CHANGE ORDER NUMBER: 2

Project: Round 1809-259Roadway: Lakeline Right Turn Lane

**Lakeline Right Turn Lane
Williamson County Project No. 1809-259**

Change Order No. 2

2851 1/2 S. LAKELINE BLVD.
LAKELINE TURN LANE
**PROPOSED SIGNAL LAYOUT -
LAKELINE/ HEB DRIVEWAY**

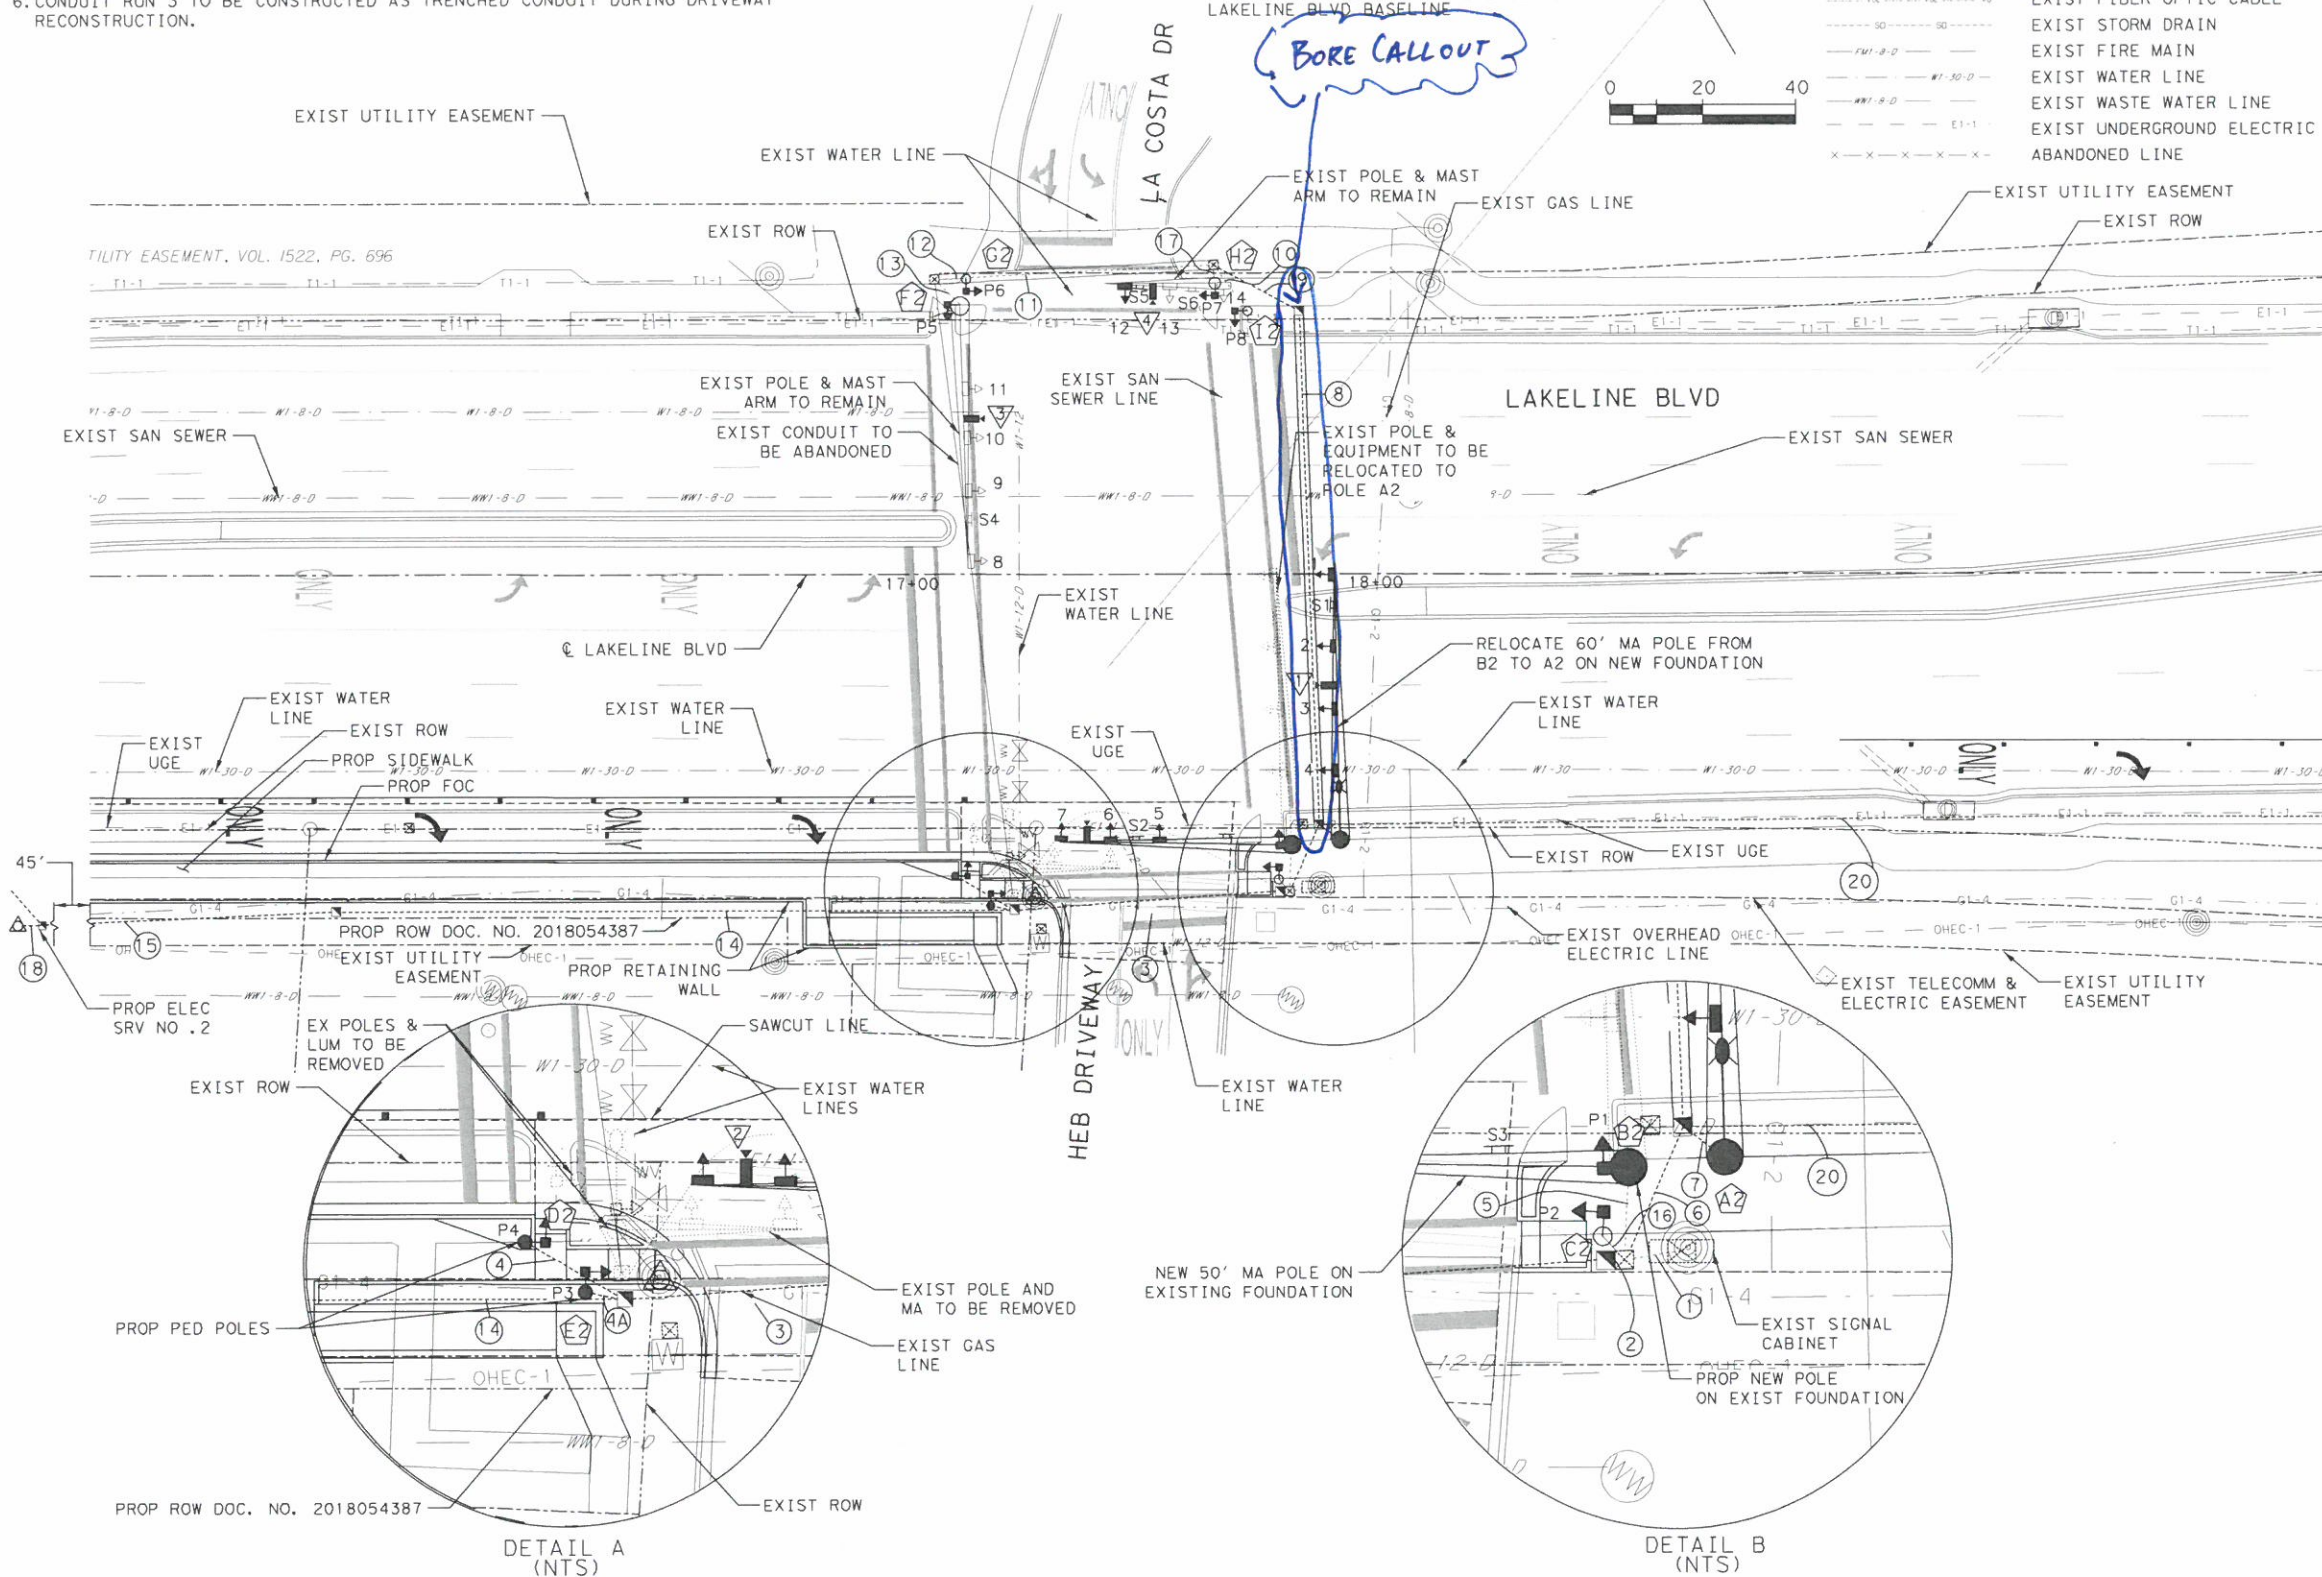
This Change Order also adds pay items for the 2-inch and 3-inch conduit bores called for in the plan items for the proposed signal at the HEB driveway. The plans called for new conduit to be bored across Lakeline Boulevard, but the pay items for this work were not included in the bid tab.

- 1) ABOVE WORK IS SHOWN IN CIVIL SHEETS-Page 29- BUT NO CONTRACT PAY ITEM
- 2) BORE PROFILE IS NOT INCLUDED- IF REQUIRED, PAYMENT SHALL BE BY FORCE ACCOUNT

ITEM	DESCRIPTION	QTY	UNIT
835S-LT2	CONDT-PVC-SCH 80-2 INCH-BORE	140	LF
835S-LT3	CONDT-PVC-SCH 80-3 INCH-BORE	280	LF
999-WC03	ELEVATED CURB ON PROPOSED SIDEWALK	1174	SF

SIDEWALK CURB DETAIL

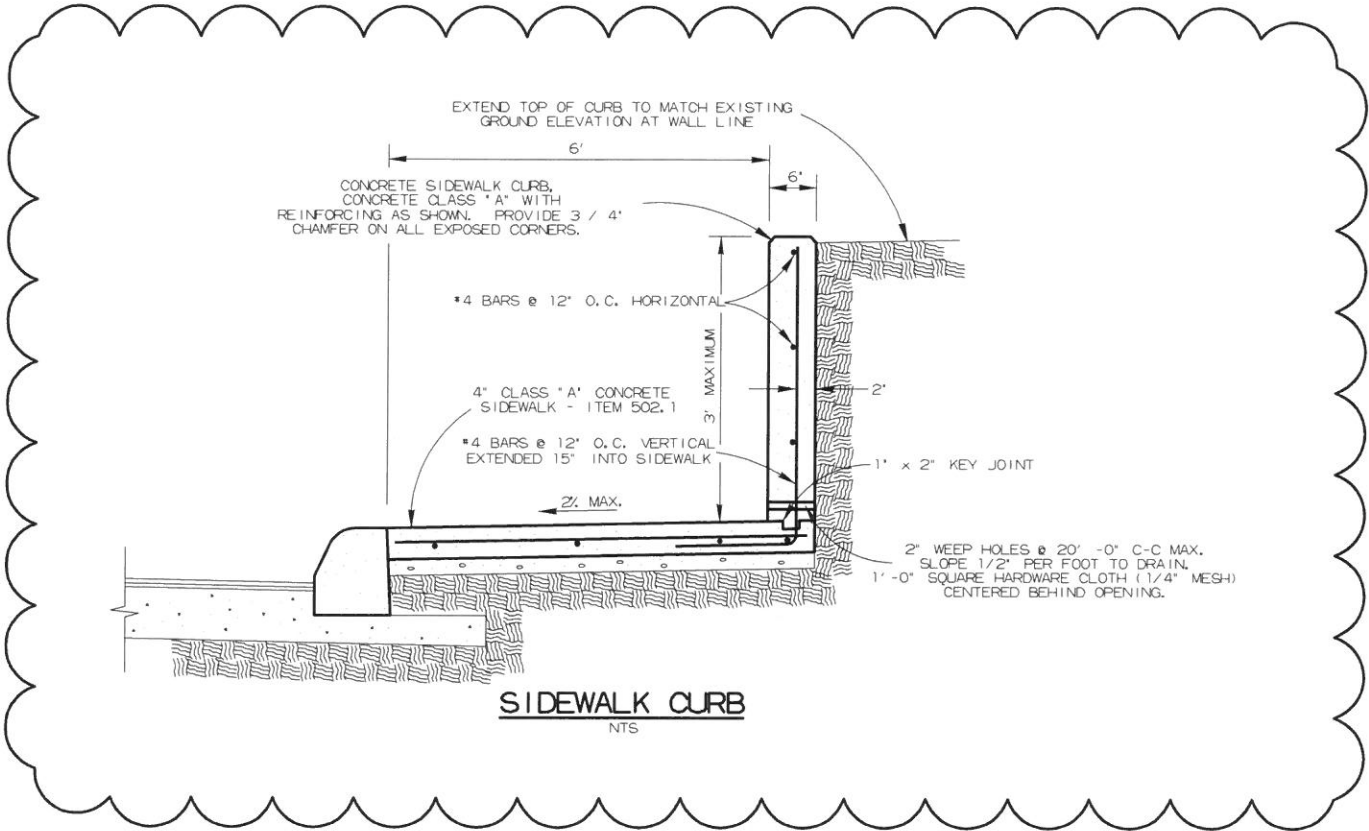
This Change Order replaces the proposed concrete block retaining wall with a concrete curb placed along the proposed sidewalk, due to the proximity of the sidewalk to the existing Austin Energy (A/E) poles. The actual location of the A/E poles put the poles too close to the proposed sidewalk and block wall. Per A/E, all construction should be a minimum of 2 feet from the poles. To provide this clearance, the wider block wall was replaced with a narrower concrete curb.

The estimate below is for 2.42ft of stand-up curb attached to the back of ±485ft of 6ft sidewalk for a total of ±1,174ft² of stand-up curb. The following estimate, and supporting documents, provide justification for a final cost of \$38.48/ft² of stand-up curb (to include the 5" of surface area covered by the adjacent sidewalk). An additional 11 days of contract time is requested as well. Final cost is inclusive of the items listed below; no other costs are included in this proposal. Final cost will be based on \$38.48/ft².
